NOV_SCE_IAG_ 20211117-01

NOTICE OF VIOLATION

Report Name: IAG SCE 20211117-01

On November 17, 2021, I performed a walking inspection of Southern California Edison (SCE) covered conductor installations, 2021 WMP initiative number 7.3.3.3.1, in the city of Moorpark, California. Detailed findings from this field inspection are laid out in Section II below.

Item3Glmg1: Pole 4920630E

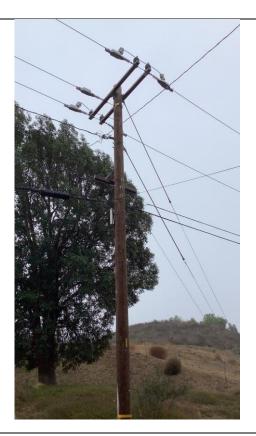
Item	Structure ID	HFTD	Initiative Number	Violation Type	Severity	Violation Description
1	382961E	Tier 3	7.3.3.3.1	Adherence to	Minor	Failure to install vibration dampers on a
				Protocol		span
2	1603388E	Tier 3	7.3.3.3.1	Adherence to	Minor	Failure to install vibration dampers on a
				Protocol		span
3	4920630E	Tier 3	7.3.3.3.1	Adherence to	Minor	Failure to install vibration dampers on a
				Protocol		span
4	2170089E	Tier 3	7.3.3.3.1	Adherence to	Minor	Failure to install vibration dampers on a
				Protocol		span

Per SCE's Distribution Design Standards (DDS) and Distribution Overhead Construction Standards (DOH), when installing covered conductor, vibration dampers must also be installed.¹ Energy Safety staff found that vibration dampers were not installed at multiple structures where covered conductor was completed. The structures missing vibration dampers where covered conductor was installed are identified in Table 2 above. On November 19, 2021, SCE submitted a memo to Energy Safety titled, "Interim Deviation from Standards on Vibration Damper for Covered Conductor" (hereafter, Memo"). This Memo was dated August 18, 2021, and indicates that due to supply chain issues, SCE will suspend the installation of vibration dampers until December 31, 2021. In accordance with SCE's Q2 QDR submission, the covered conductor installations inspected by Energy Safety were completed prior to the issuance of the Memo. Also, SCE informed Energy Safety of this supply chain issue only after inspections commenced. Consequently, Energy Safety finds that SCE is still in violation of its protocols requiring the installation of vibration dampers as part of covered conductor installations.
